Subject: **PA BOARD REPLACEMENT**

Model: **BVM-1310, BVM-1410, BVM-1410C**

Figure 1

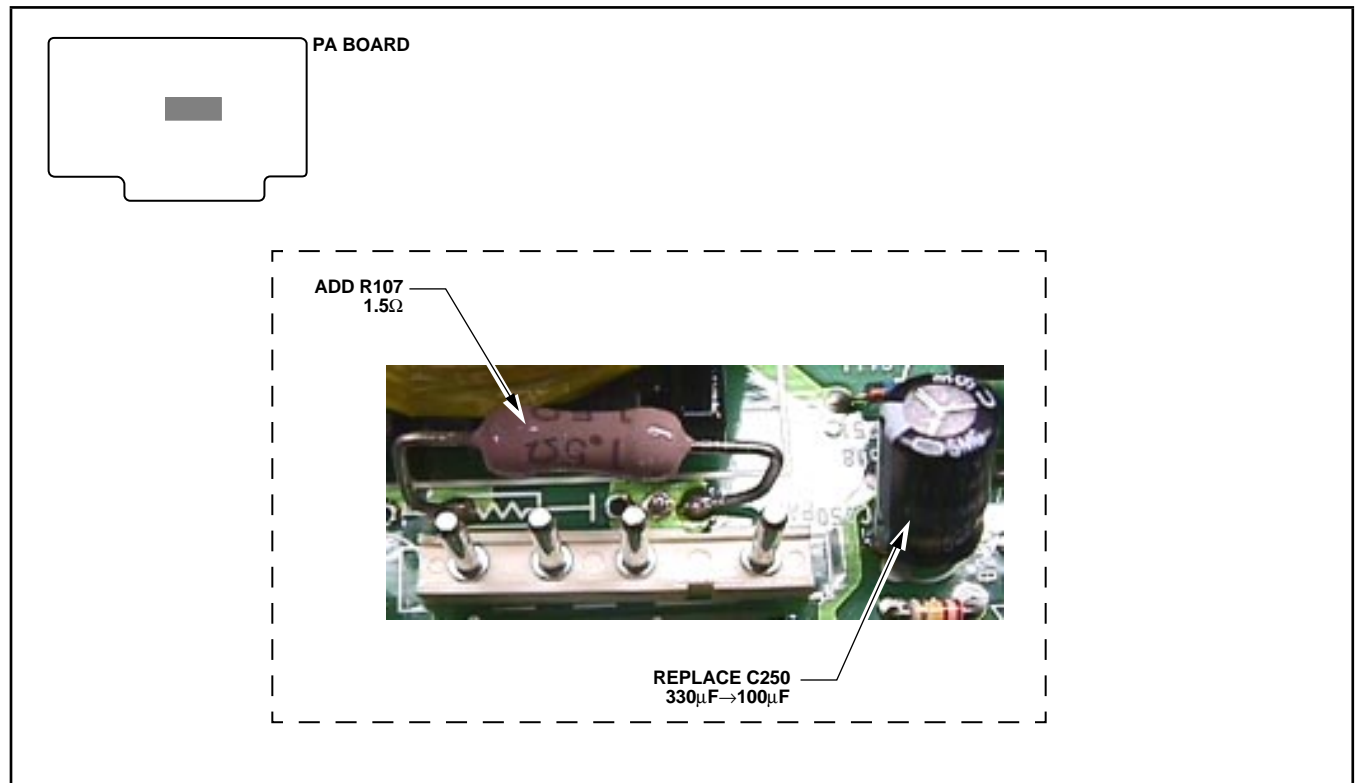
When using the PA board (A-1345-598-B), add a 1.5Ω resistor (R107) and replace capacitor (C250) as shown in Figure 1.

Part No.	Description	Qty.
1-104-665-11	Cap, 100μF/25V	1
1-216-371-00	Res, 1.5Ω, 2W, Metal Oxide	1
